VOLUME 2

## DONALD C. COOK NUCLEAR PLANT

## UNITS 1 AND 2

# CONTROL ROOM DESIGN REVIEW

# Typical VS Panel Fan Control

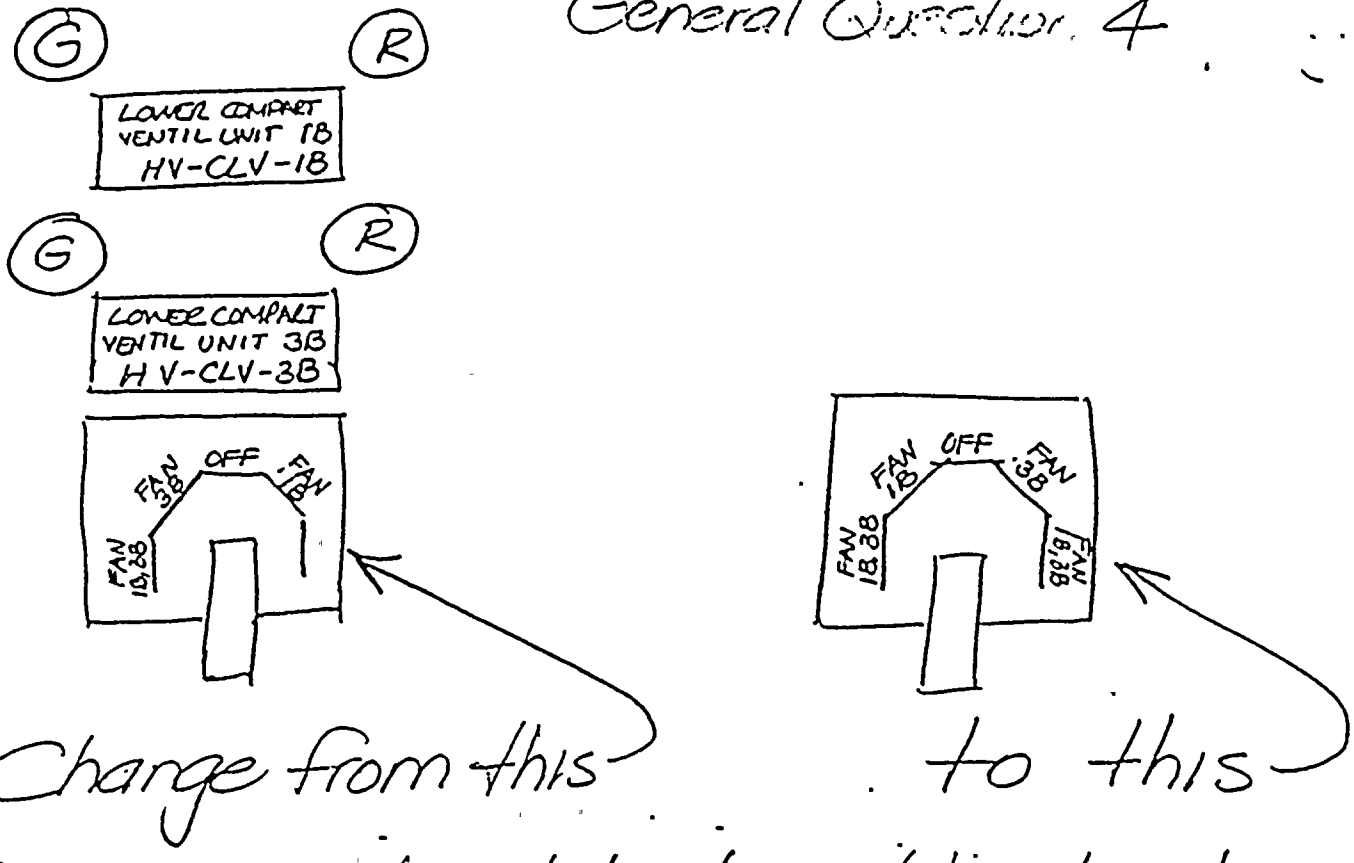
Ref to Operator Questionnaire ...
General Question 4

Reasons: Need to be able to turn on either fan from OFF position

Change from this ... to this

Cook DCRDR CLO 4.1-16&17

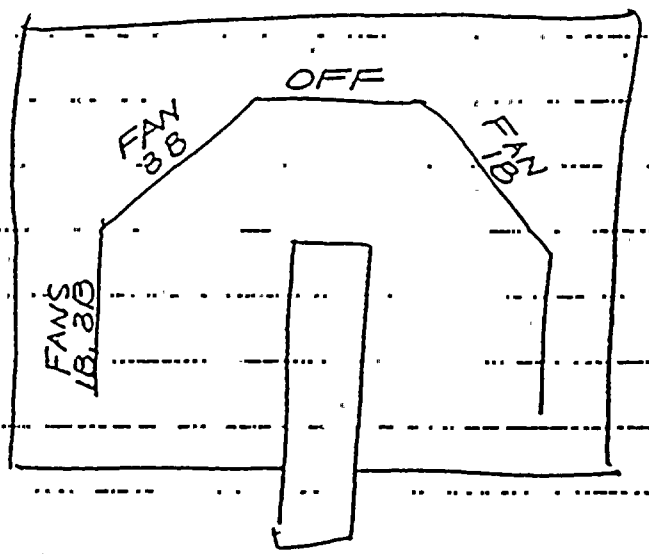
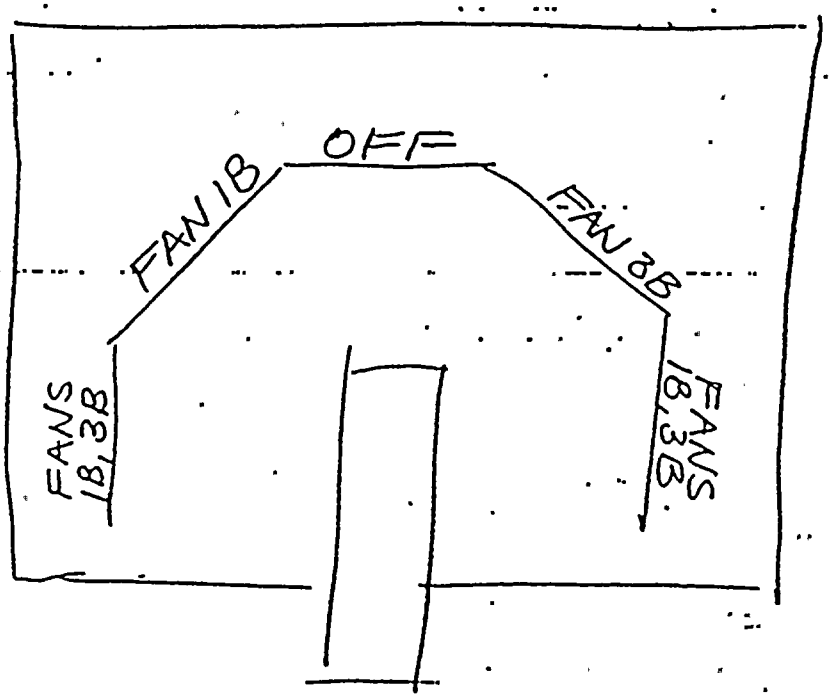
Example of present control switch positions:

Proposed Solution: Rewire and relabel control switches per below example:

Can start either fan from OFF position and can go to two fan operation from either single fan operation without shutting down fan.

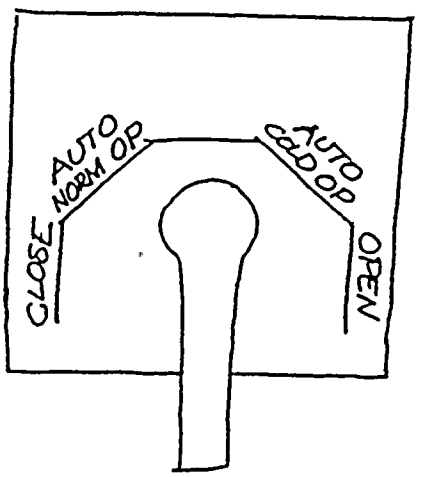
Rewire PRZ-38&39 for following positions:

Blank 12 O'clock Position same as AUTO-NORM OP

Remove PRZ-47&48 from panel, no longer required.

AUTO-NORM OP is the same as old PRZ-38&39 in AUTO and PRZ-47&48 in BLOCK

## PROBLEMS WITH PRESENT ARRANGEMENT

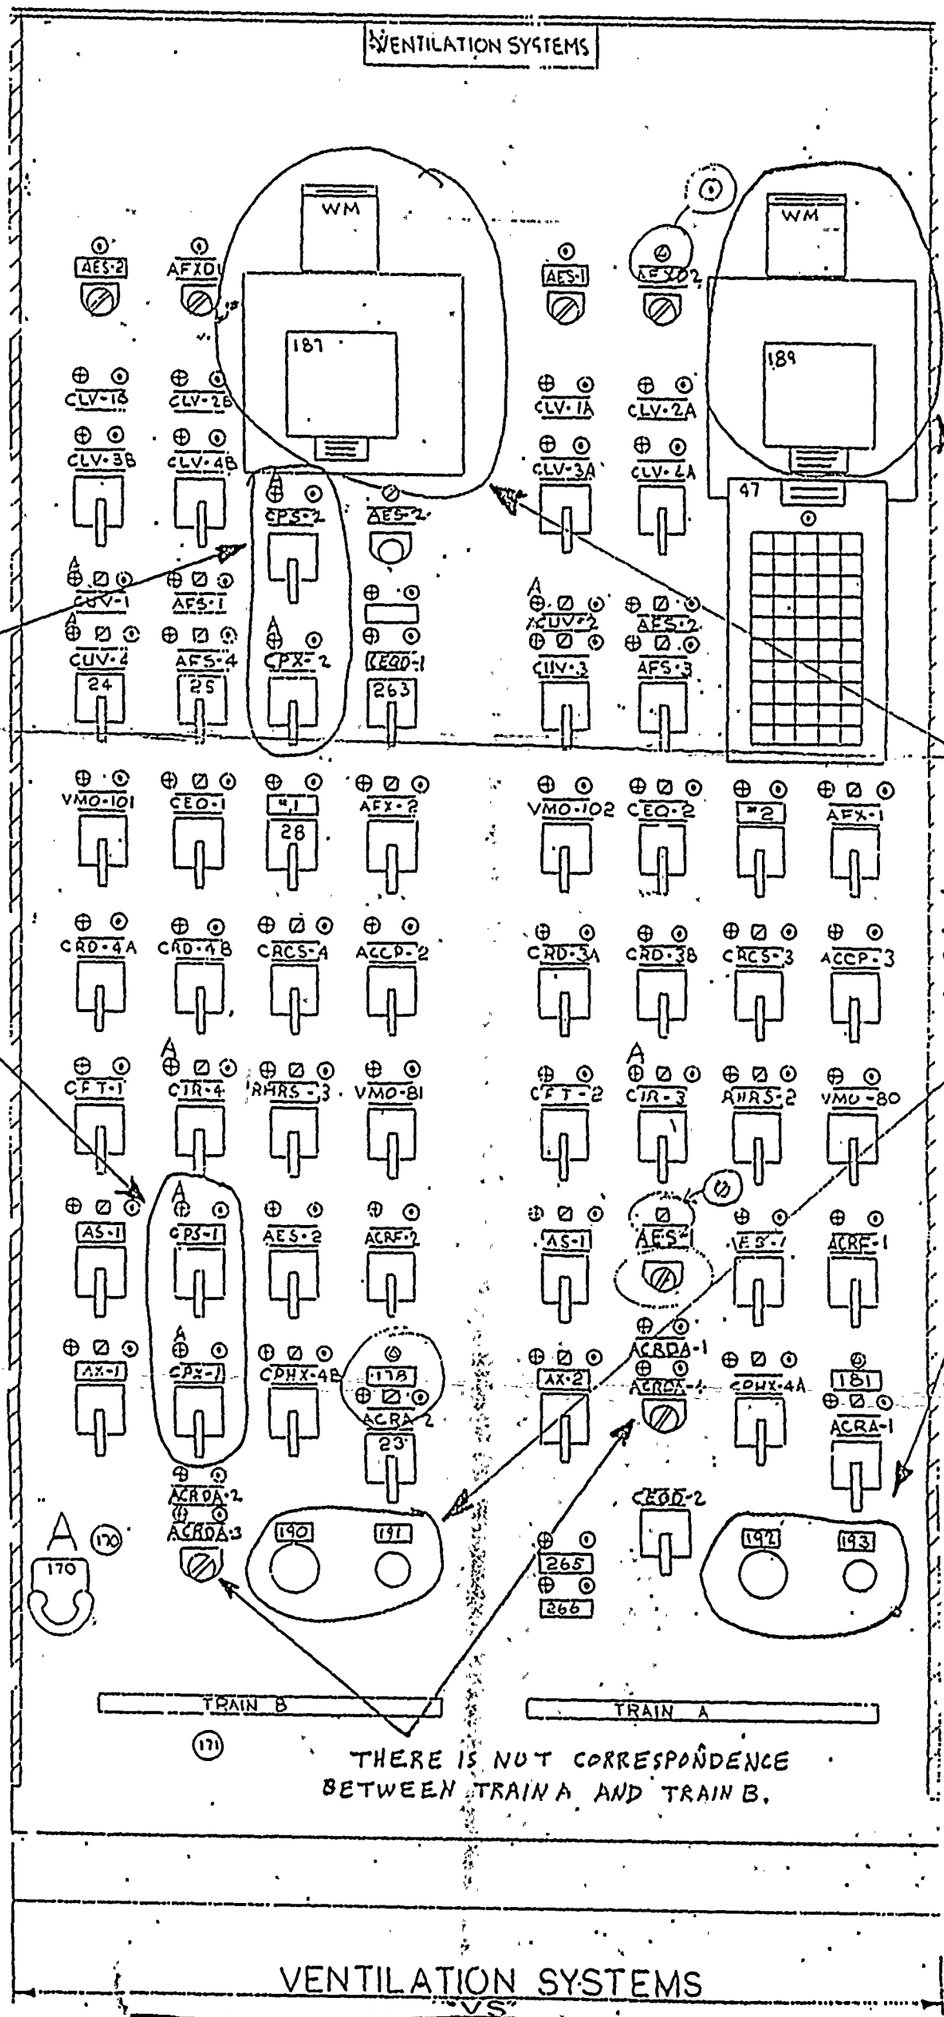
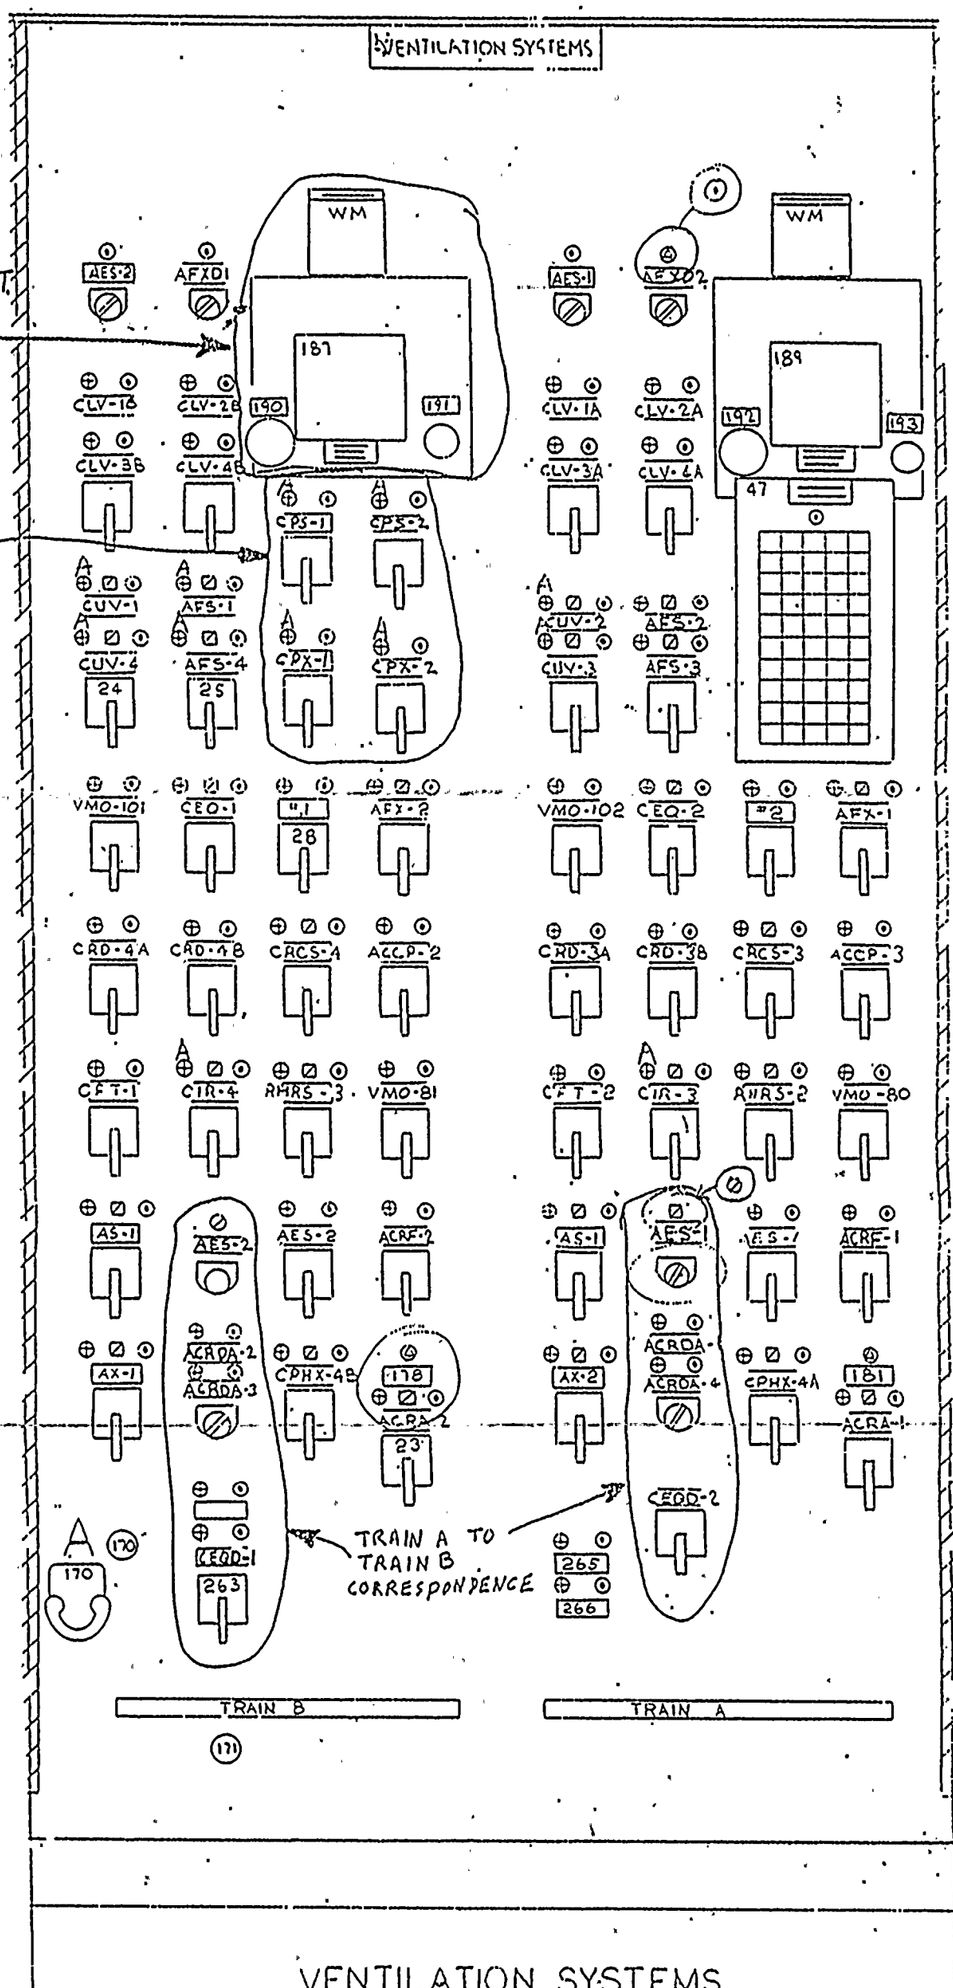
CPS-1 AND CPS-2 ARE NOT BY EACH OTHER.
CPX-1 AND CPX-2 ARE NOT BY EACH OTHER.

H2 RECOMBINER POTENTIOMETER AND TEMPERATURE SELECTOR SWITCH NOT LOCATED CLOSE TO TEMPERATURE AND WATTS INDICATORS

H2 RECOMBINER POT. & TEMP. SELECTOR PLACED BY THE INDICATORS

SWITCHES PLACED TOGETHER AND IN LEFT TO RIGHT ORDER
